To:	Ryhan Thompson	At:	Indesco Pty Ltd
From:	Carly Roder	At:	SLR Consulting Australia Pty Ltd
Date:	26 November 2019	Ref:	660.20071-M01- Cooby Road Peer Review -v1.0.docx
Subject:	Peer Review 105 Cooby Road, Tullimbar NSW

Indesco Pty Ltd (Indesco) has engaged SLR Consulting Australia Pty Ltd (SLR) to undertake high level peer review of the Northern Area Precinct 5, within the proposed residential development off Cooby Road, Tullimbar New South Wales.

Figure 3: Terrain Units defined by Terra Insight, 2019.

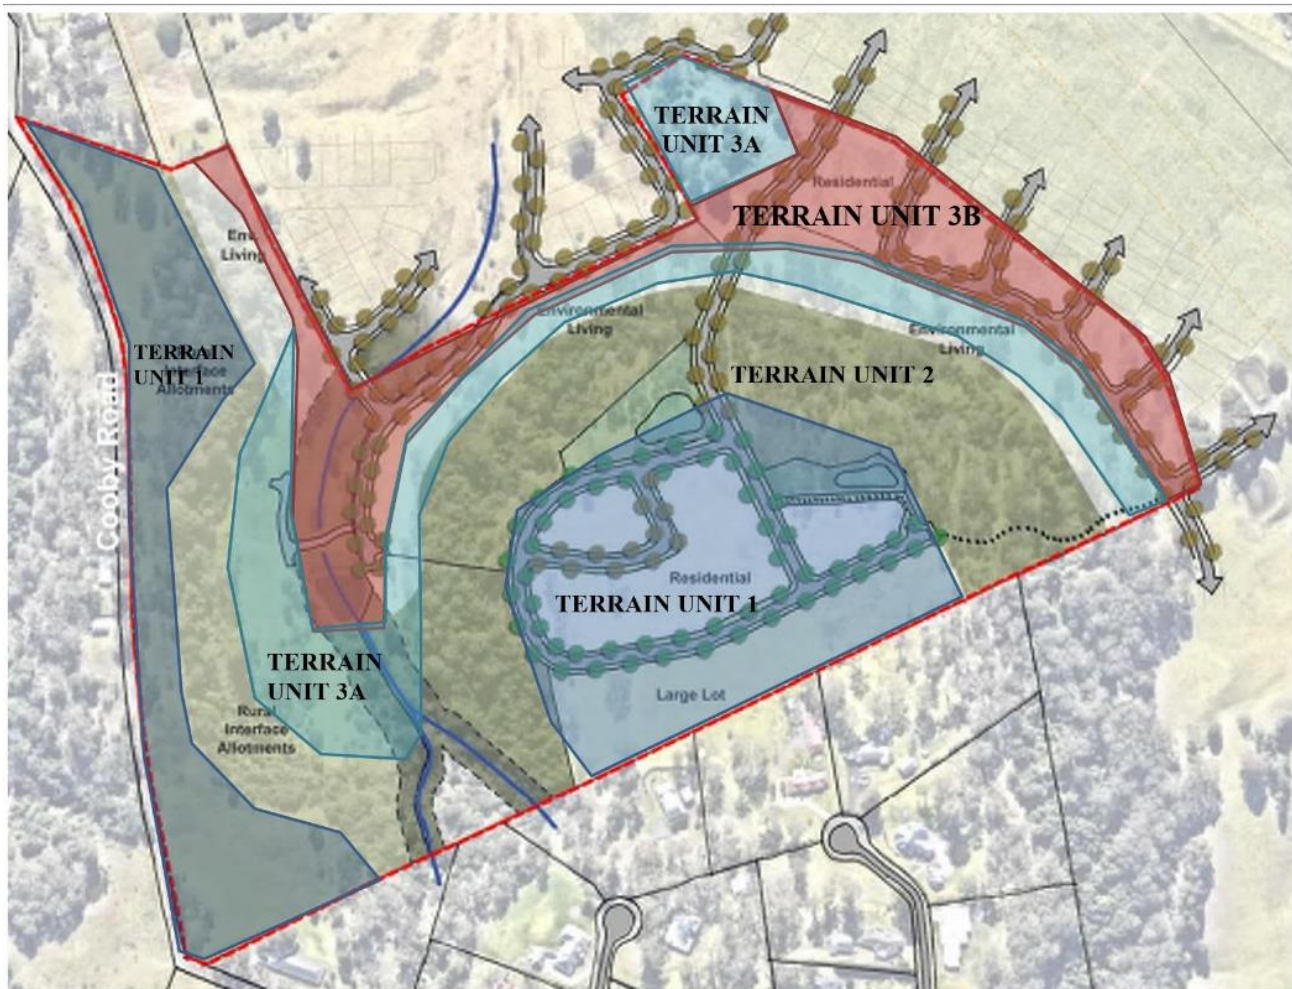
Terra Insight (2019), classifies Terrain Unit 3A to be inclusive of Northern Area Precinct 5 and the area downslope of the upper steep slopes of Terrain Unit 2 (**Figure 3**). The terrain in Terrain Unit 3A is identified to be moderately to steeply graded upper valley slopes underlain by <1.5m of colluvial soils, residual soils overlying bedrock (Bumbo Latite and/or Berry Formation). Terra Insight (2019) assessment of the Northern Area Precinct 5 identified that potential land instability mechanisms included surficial creep, local and large-scale slope failure or rock fall on the slopes.

While SLR agree with the categorisation approach taken by Terra Insight, 2019, SLR believe the Northern Area Precinct 5 has been classed at a moderate risk of landslide due to its characteristics being extrapolated to fit within Terrain Unit 3A.

SLR consider Northern Area Precinct 5 to be a different terrain unit to Terrain Unit 3A which lies directly below Terrain Unit 2, as it does not have the inherent risks that result from proximity to the steeply sloped Terrain Unit 2, i.e. the Precinct 5 area is not considered to lie within the travel distance of any potential instability originating within Terrain Unit 2.

Based on the above observations, SLR consider that Northern Area Precinct 5 be re-classified as a separate terrain unit with the following defining characteristics:

- **Terrain Unit 4 – Shallow Rock Slope:**
Moderately graded shallow bedrock slopes, overlain by superficial soil, with low gradient foot slopes comprising < 500 mm residual soil overlaying shallow bedrock.

Figure 8: Cross Section West to East across Northern Area Precinct 5

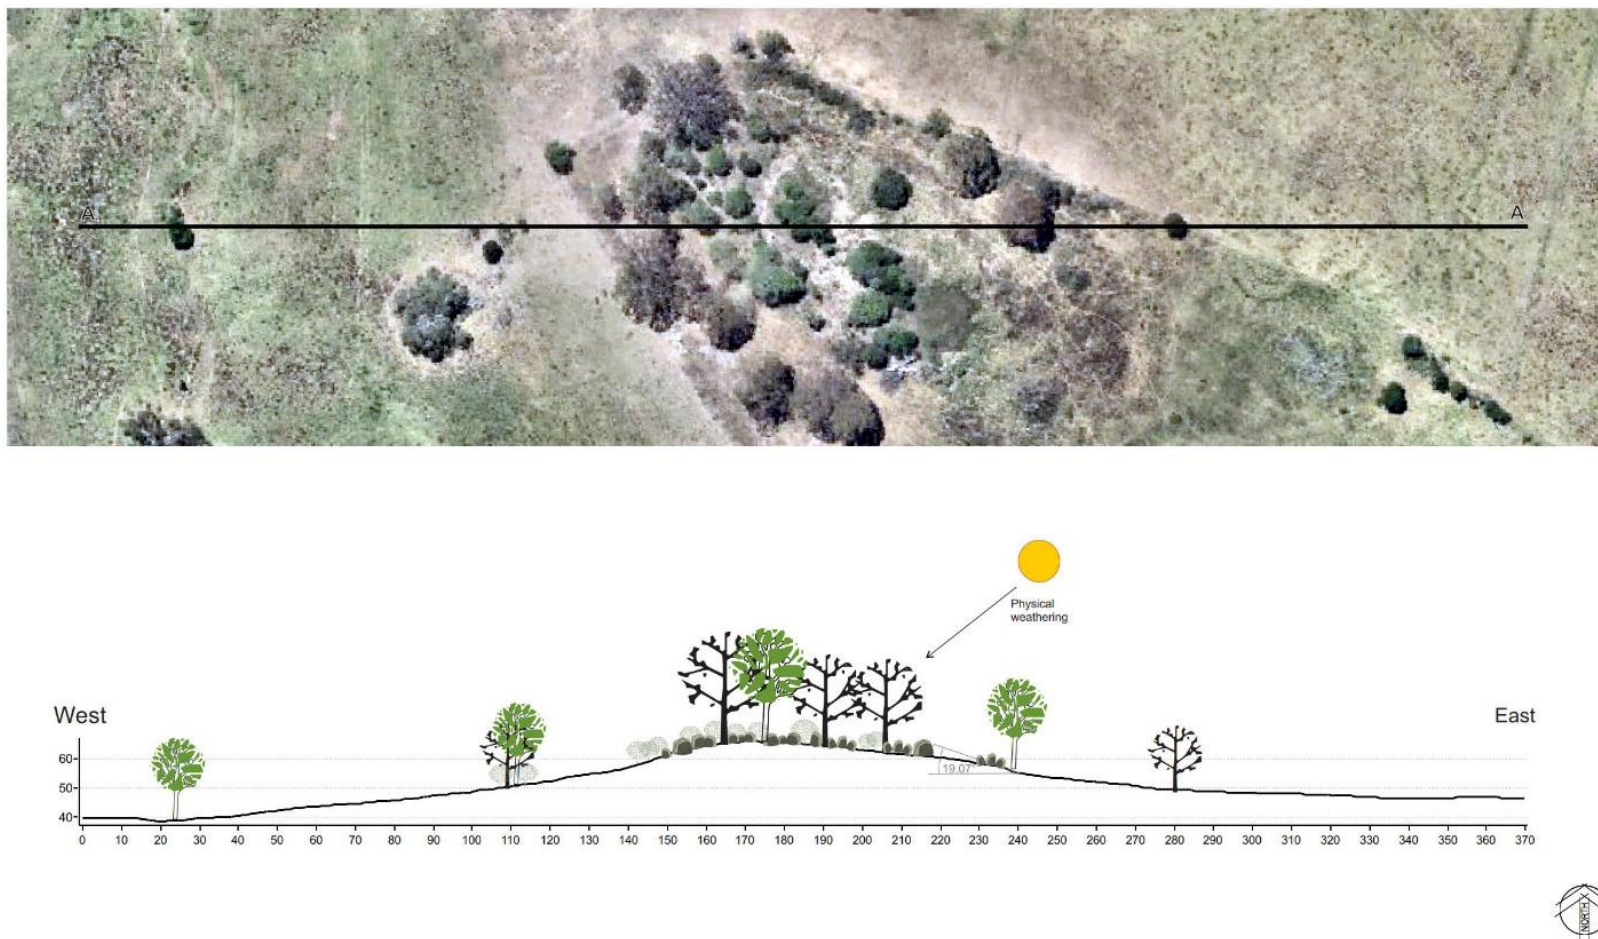
SLR attended the proposed Northern Area Precinct 5 on 25th November 2019. Typical photographs of the geomorphology at Precinct 5 are included in **Figure 6 and 7**. A typical cross section through Precinct 5 landform is included in **Figure 8**. A summary of the site observations is included below:

- The slopes are moderately sloping at approximately 15 degrees, with localised steep slopes on the northern side of the hill at generally less than 25 degrees (**Figure 6 and Figure 8**);
- Latite bedrock is visible at surface as tabular cobbles and boulders, mostly covered in moss, showing signs of in-situ physical weathering on the northern hill slope (**Figure 7**);
- A thin cover of residual soil / topsoil overlies the lower hill slopes;
- Vegetation includes grass with interspersed larger native trees and shrub-like trees on hill crest;
- No visible signs of slope movement were observed.
